# Access Compliance Report

## Public Rights-of-Way

| Intersection ID: 17870                  | Main Street: HILLSDALE_AV | Cross Street: TRANQUIL_AV               | Location: SE           |
| ADA ID: 14E56ADF93B4                    | Ramp Type: Perp           | Initial Pass/Fail: Fail                 | Overall Compliance: No |

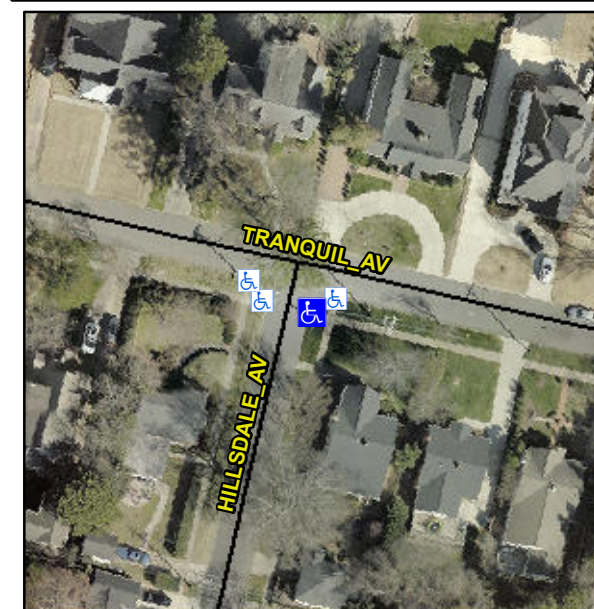
**Not Found, R304.5.1, R304.2.2, R304.5.3**

| Compliance | Description           | Data  | Compliance | Description                 | Data |
|------------|-----------------------|-------|------------|-----------------------------|------|
| N/A        | Ramp Length (in)      | 111.0 | No         | Ramp Slope (%)              | 14.1 |
| No         | Ramp Width (in)       | 42.0  | No         | Ramp XSlope (%)             | 5.7  |

**Remove & Replace Entire Ramp.**
